**Central Campus**  
Austin Street Improvements  
1300 Holman Street  
Houston, TX 77004

#### **Contractor Questions & AE Responses:**

Central Campus  
San Jacinto Memorial  
Green Improvements  
1300 Holman Street  
Houston, TX 77004

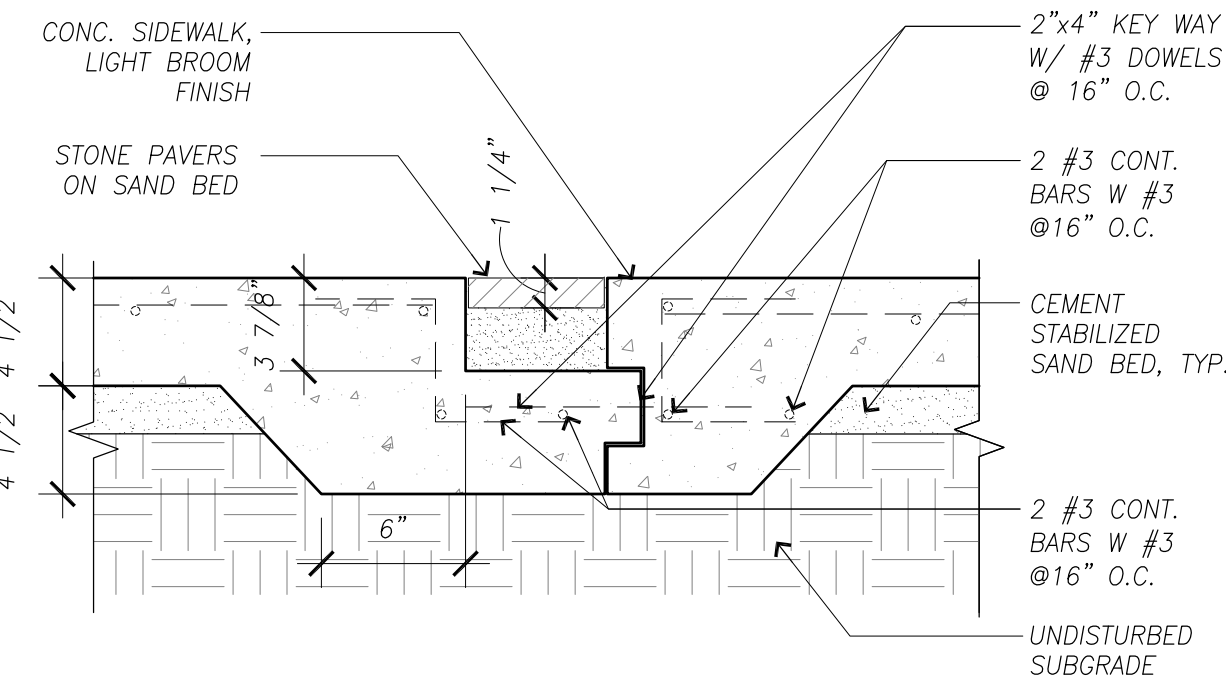
1. Drawing LP-1.01 SanJac Mem.: what is the unidentified texture pattern surrounding the 15 Allee Elm square planters?

***AE Response: There is crushed limestone at base of tree and decomposed granite around that. Please see Addendum 001 – LP -1.01.***

10 Planter Edge Paving Detail  
SCALE: 1 1/2" = 1'-0"

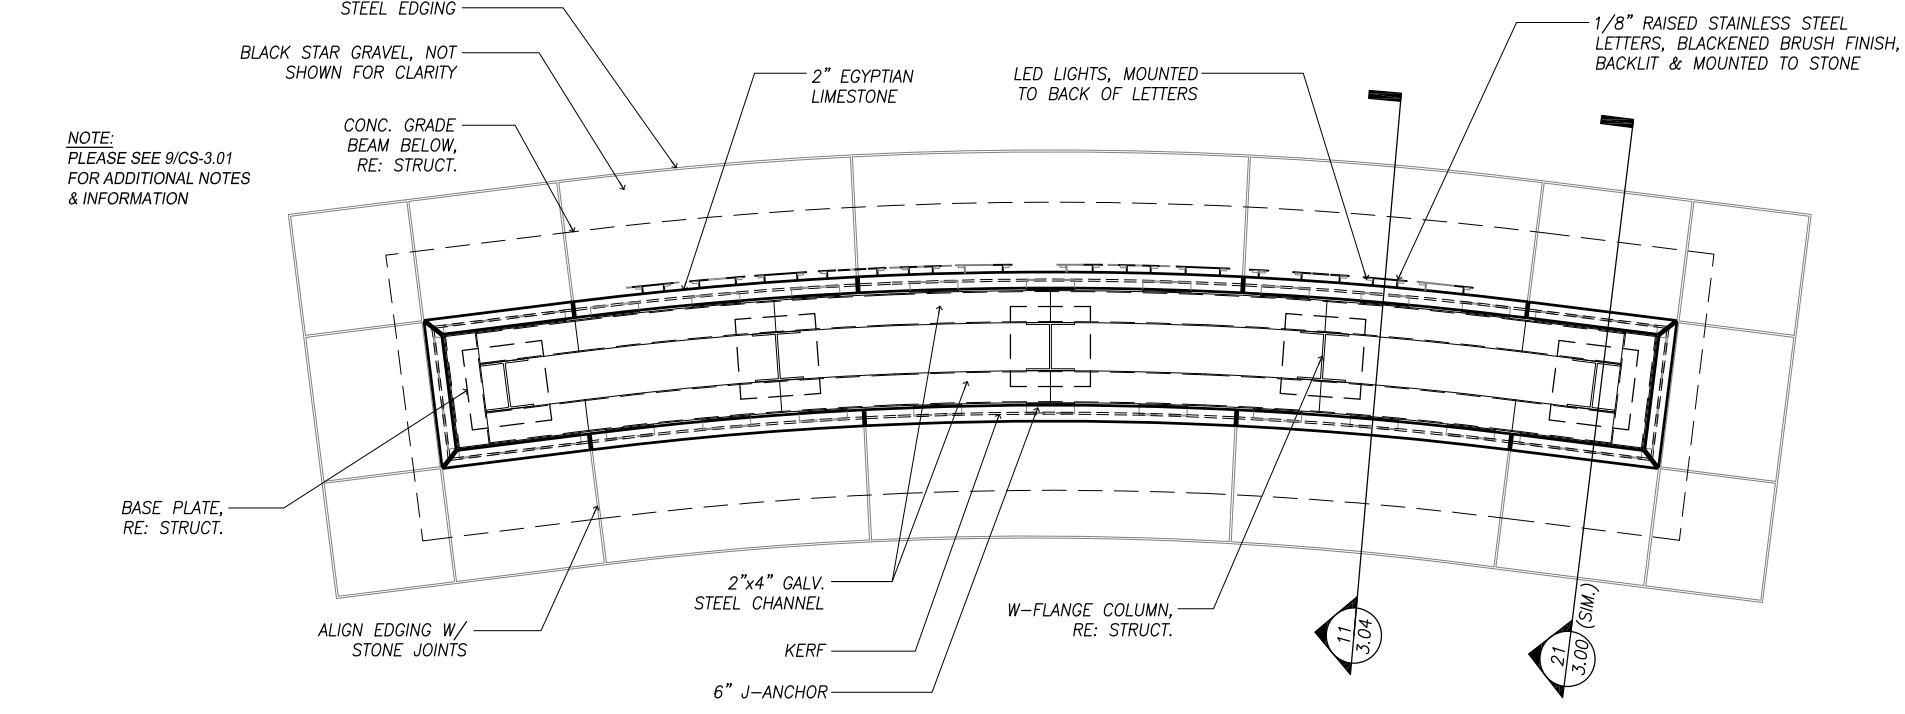
2. FYI: Drawing AS-3.04 has two (2) detail 10's.

***AE Response: Please see Addendum 001***

Irrigation Site Plan

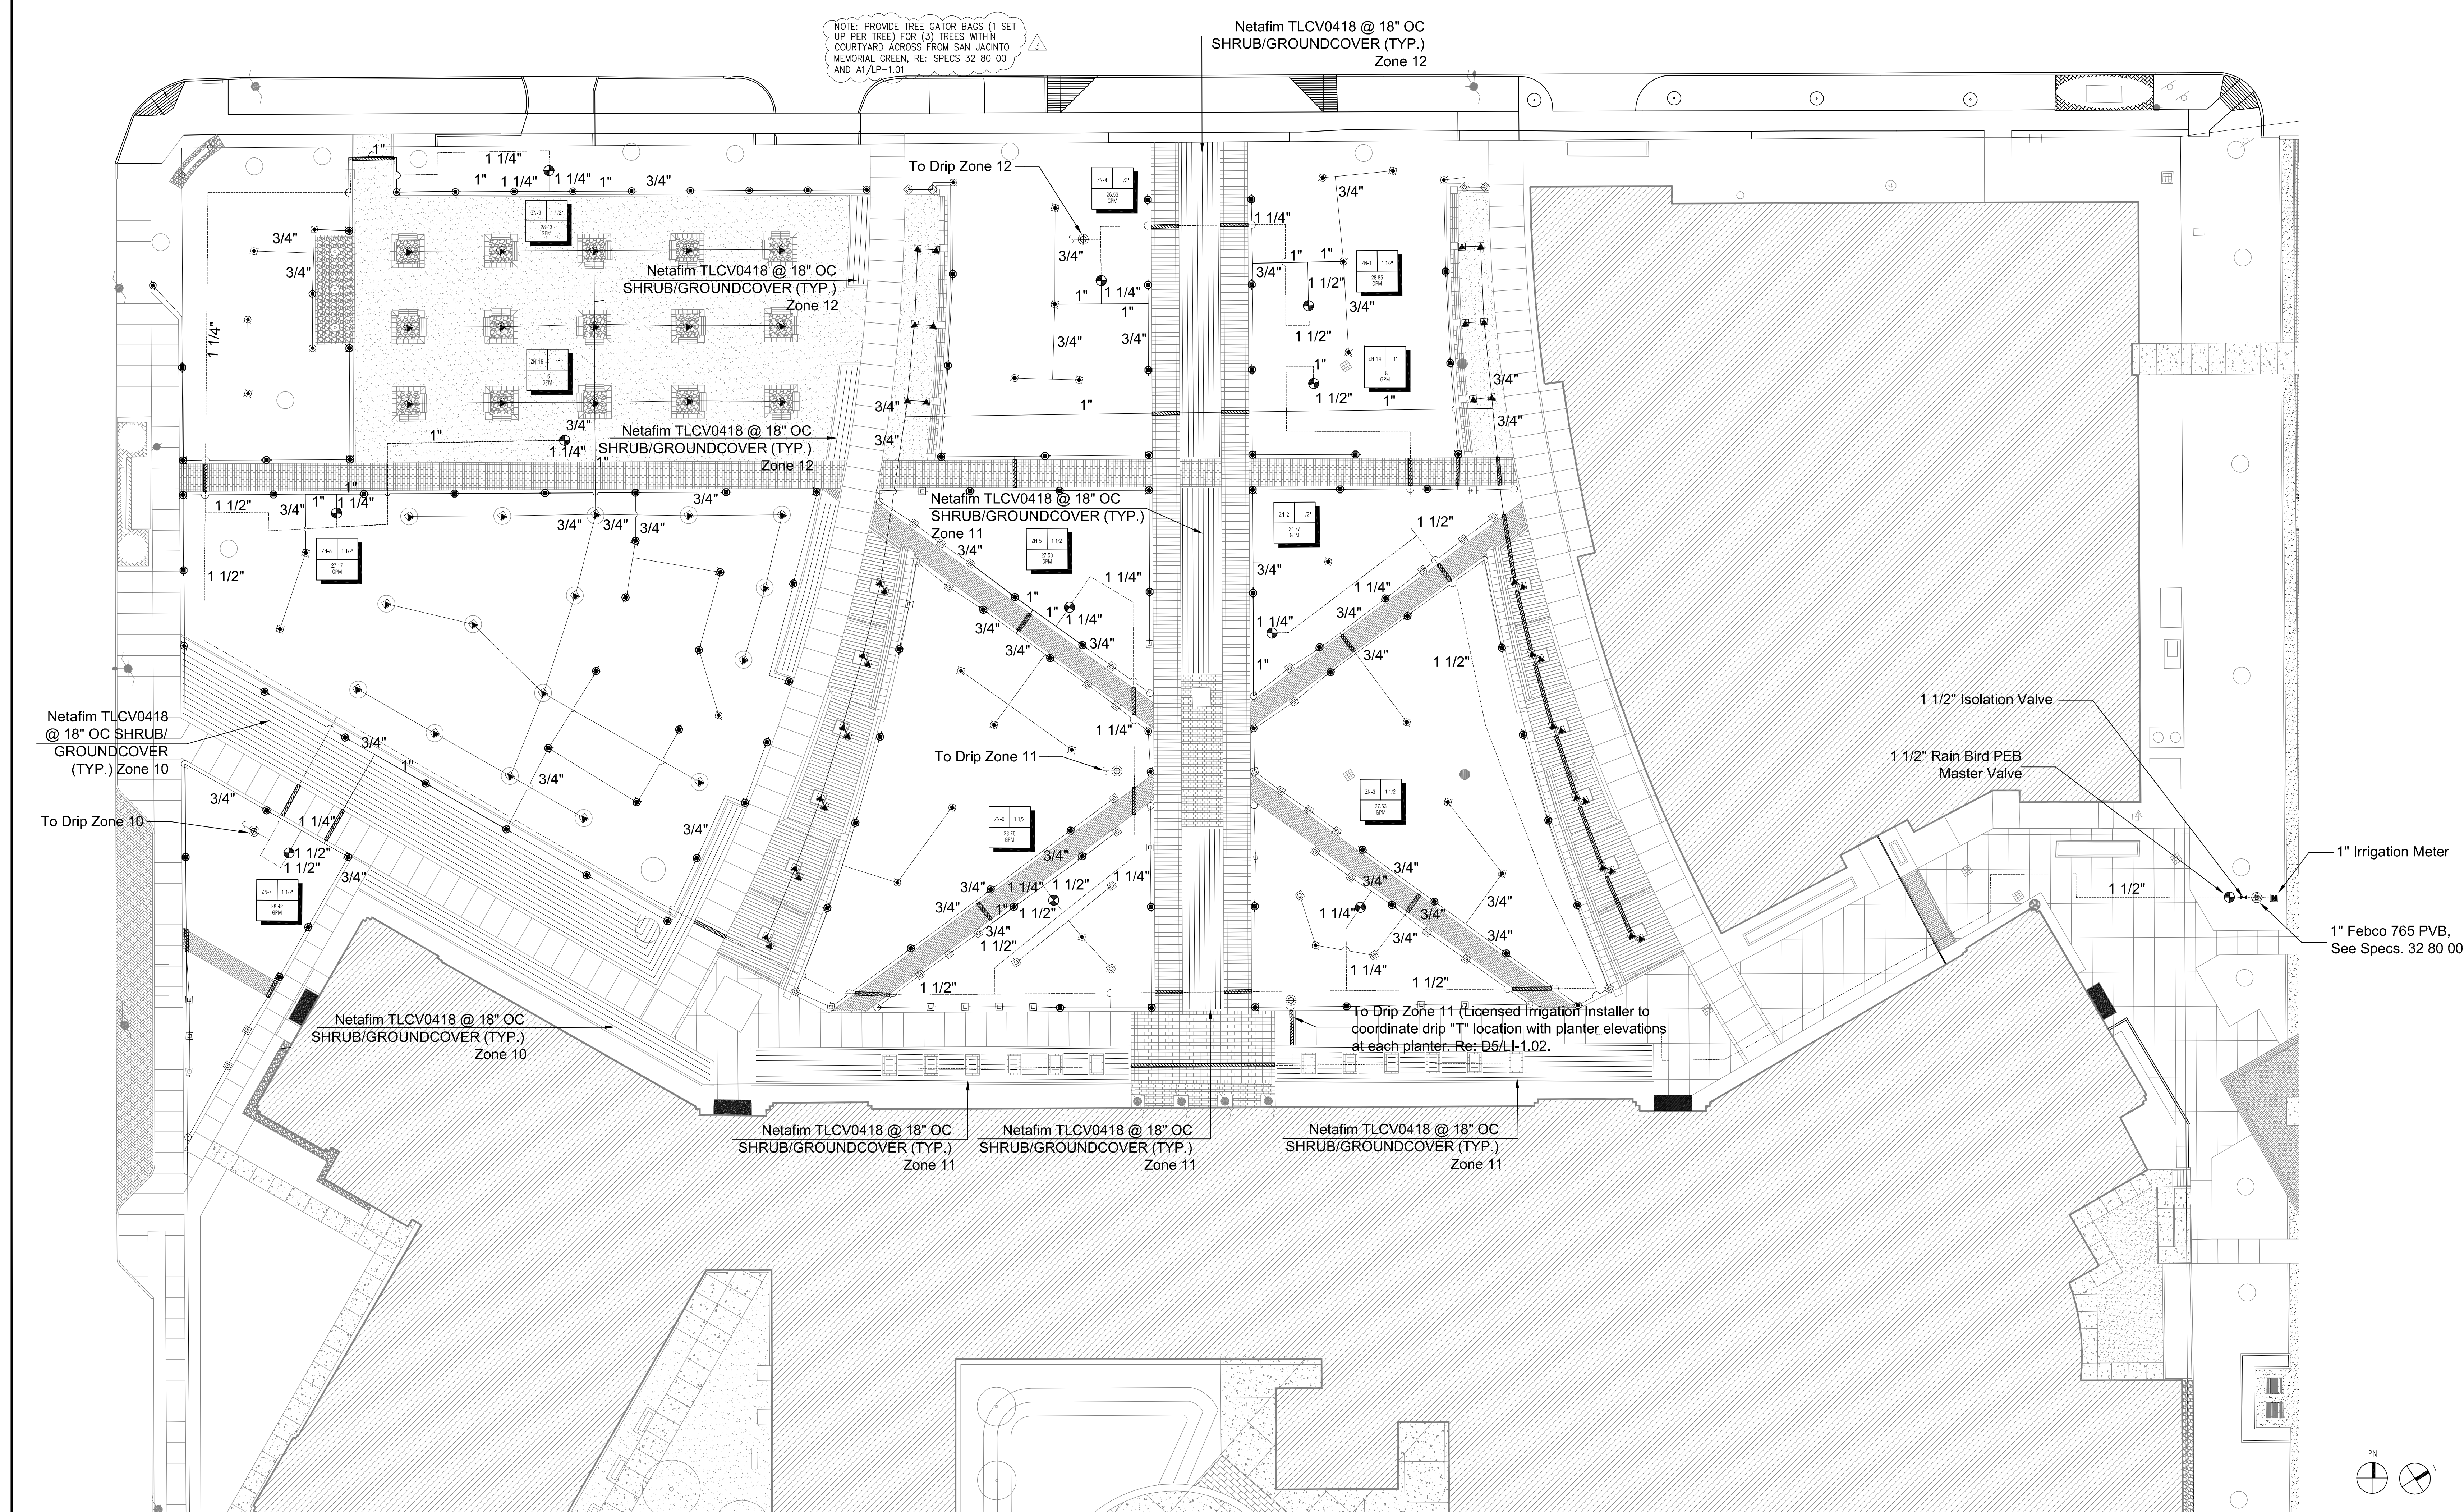
2. Does the area across Holman Street require irrigation?

***AE Response: (3) Trees within the courtyard across San Jac Plaza are to use Treegator bags for watering. Please reference spec 32 80 00.***

NOTE: PROVIDE TREE GATOR BAGS (1 SET UP PER TREE) FOR (3) TREES WITHIN COURTYARD ACROSS FROM SAN JACINTO MEMORIAL GREEN. RE: SPECS 32 80 00 AND A1/LI-1.01

Description: PLAZA PEDESTRIAN PAVER DETAIL		Sht No. 1 OF 1	Detail No. SKC-2
Scale: N.T.S.	Drawn By: ESPA Checked By: WVW Date: 1/17/2014	ESPA Project No: 2166-024

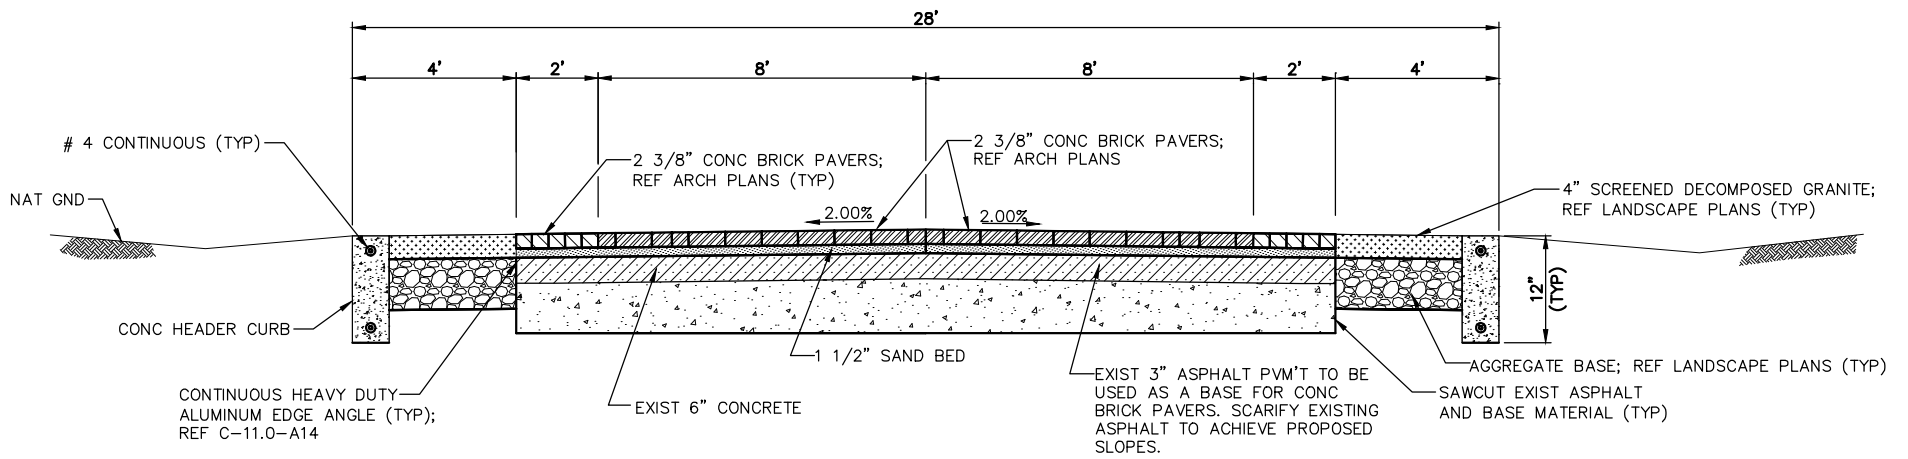
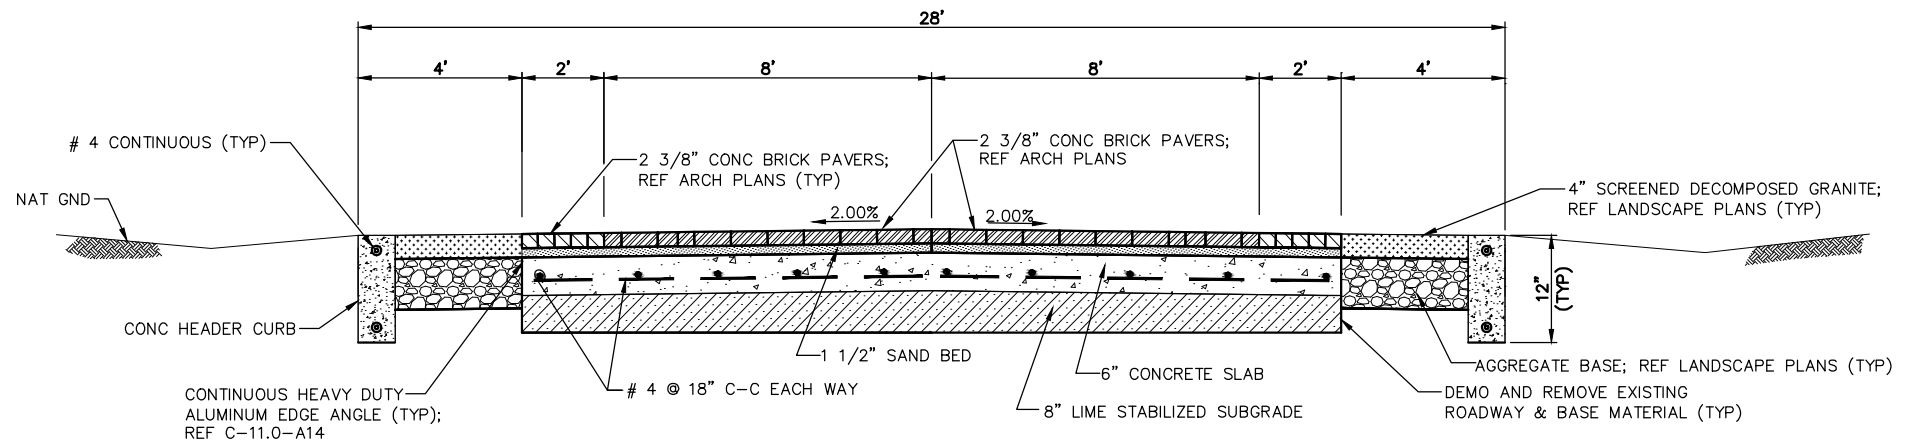
- Drawing C-5.0 Note 17 references detail A12 on C-11.0.  
Detail A12 is a curb and gutter design. Is this the correct type of curb to use at the perimeter of the decomposed granite?  
*AE Response: No. Please see SKC-2-Rev 1 – Addendum 001.*
